| Notes   |  |  |  |  | No. | Date       | Revision   | Initials |
|---|--|--|--|--|-----|------------|--|----------|
| 1. Copyright Reserved   |  |  |  |  | P01 | 06.10.2023 | Planning Permission Application - General Amendments | WG       |

| Project                                   |          | 6-7 HARDCOURT TERRACE, DUBLIN 2, IRELAND |            |
|---|----------|--|------------|
| RESIDENTIAL APARTMENTS, LISIEUX PARK      |          | 1 + 303-1-818 2100 1 + 303-1-818 7385    |            |
| Drawing Title                             |          | Proposed East Podium Elevation           |            |

1  
2008 1:200  
PROPOSED EAST PODIUM ELEVATION (BLOCKS 3&4)

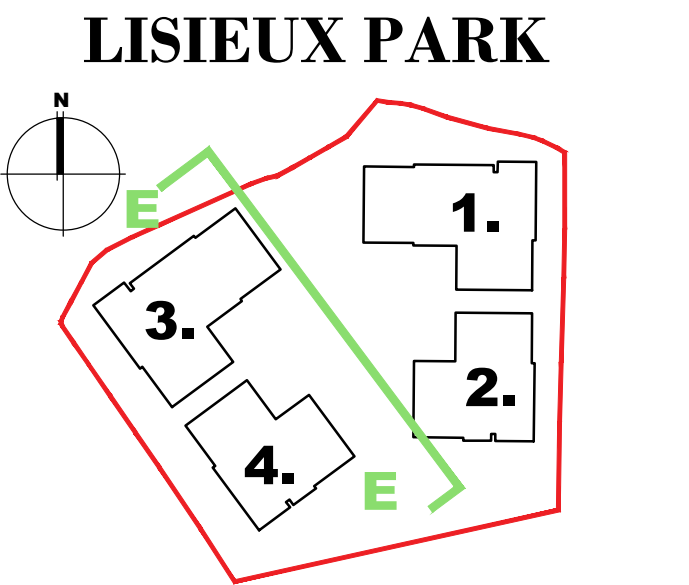
- CHANGES FROM SCHEME PERMITTED UNDER ABP-307415-20:**
- (1) ALL PERMITTED BEDROOM DOORS OPENING ON TO BALCONIES CHANGED TO WINDOWS TO IMPROVE SAFETY AND SECURITY.
  - (2) PERMITTED GLAZED ATRIUM AT ROOF LEVEL (ABOVE STAIR AND LIFT CORE) REMOVED FOR FSC PURPOSES
  - (3) GLAZED LINK CORRIDORS BETWEEN BUILDINGS REMOVED
  - (4) FENESTRATION SHOWN IN ELEVATION TO TALLY WITH PERMITTED PLANS
  - (5) LINK BETWEEN BUILDINGS REMOVED AND 2 NEW WINDOWS ADDED IN ITS PLACE
  - (6) MINOR CHANGES TO FENESTRATION TO ACCOMMODATE IMPROVED APARTMENT FLOOR PLANS
  - (7) NON-STRUCTURAL COLUMNS OMITTED FROM BALCONIES TO IMPROVE DAYLIGHT INTO APARTMENTS
- NOTE: TREES SHOWN AS INDICATIVE ONLY. REFER TO THE ARBORISTS REPORTS, TREE PROTECTION PLANS AND LANDSCAPE MASTERPLAN FOR DETAILS ON ALL TREES
